**ZONING MAP CHANGE
STAFF REPORT**

ZC-20-039

**WATERCHASE CONDOS
FORT WORTH, TEXAS**

**TOWNHOME
SITE PLAN**

SHEET NO.
CSP

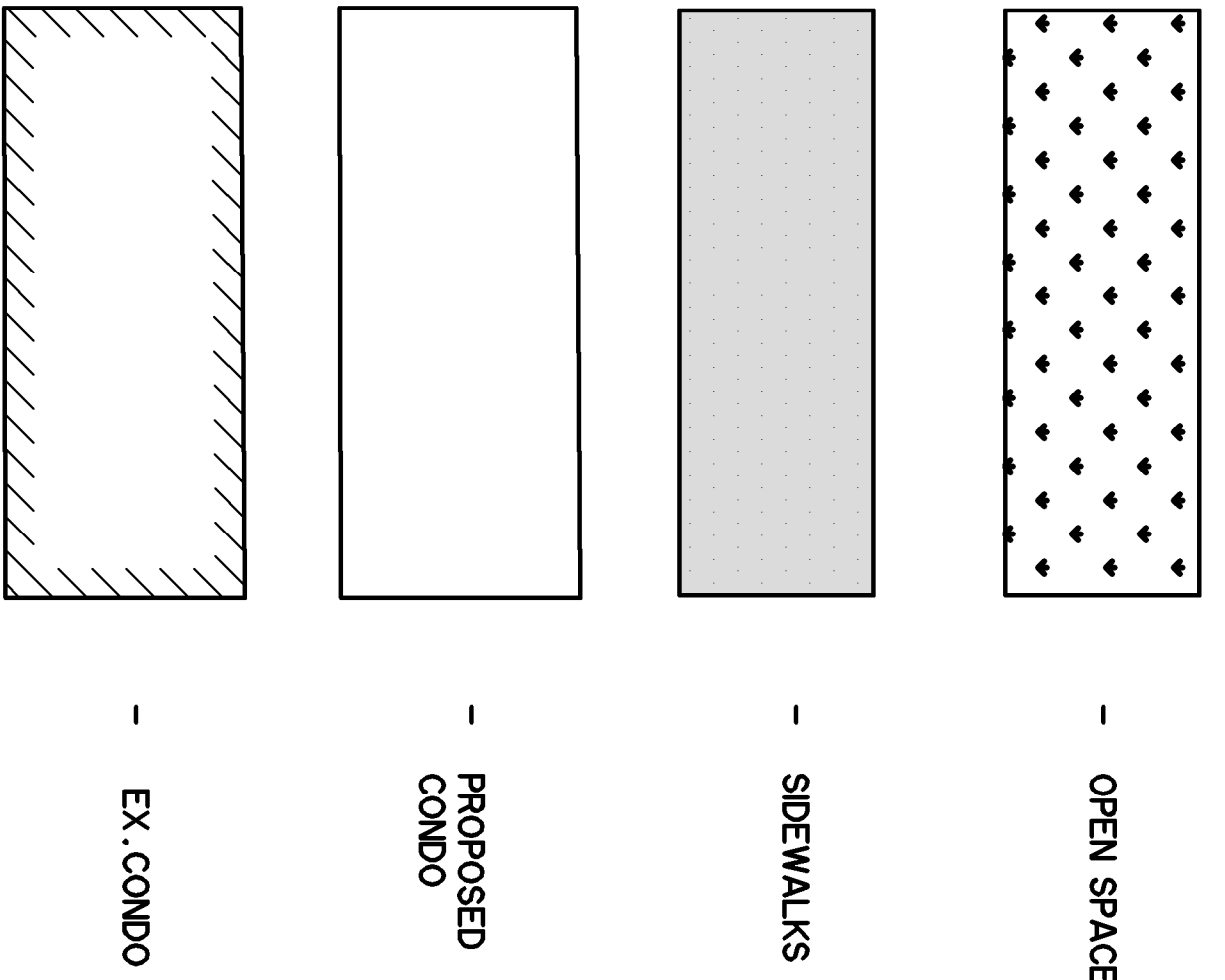
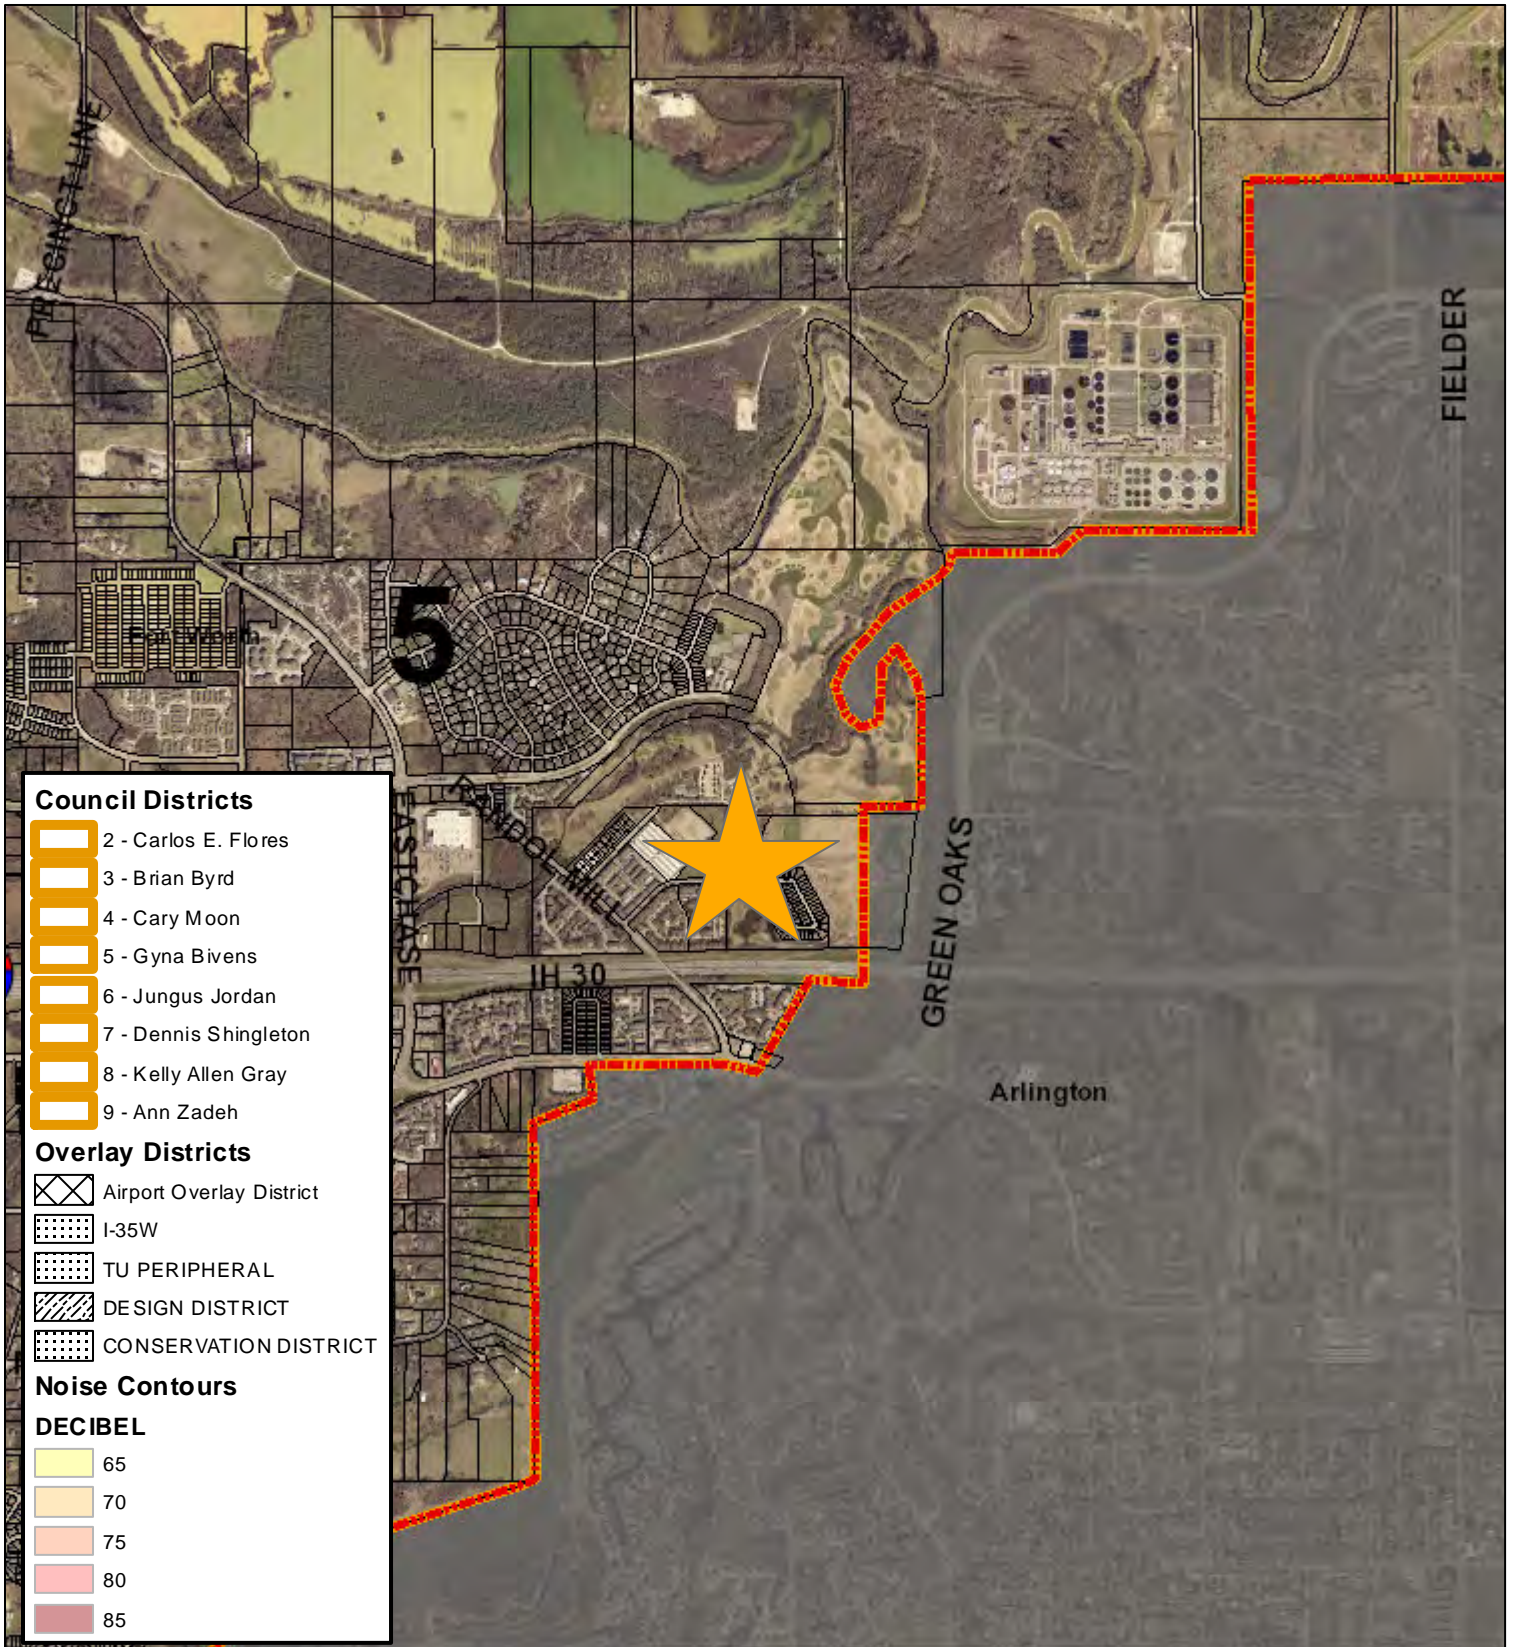
The site plan as submitted is not in general compliance with the Zoning Ordinance regulations.

1. The applicant is requesting not to submit an MFD site plan submittal **(development regulation standard, recommended approval)**
2. The proposed site plan does not indicated compliance with the MFD façade variation standards **(development regulation standard, will comply)**

3. Building #3 on the site plan does not comply with the 20 ft. front yard setback along Creek Run **(development regulation standard, recommended approval)**

4. Proposed 6 ft. wood fence extends beyond the building front. **(development regulation standard, recommended approval)**
5. Parking is not allowed between a building and a public or private street **(development regulation standard, recommended approval)**

6. The parking ratio is 1 space per bedroom plus 1 space per 250 sf of common space, which would requires a minimum of 39 parking spaces. The site plan indicates 26 spaces. **(development regulation standard, recommended approval)**
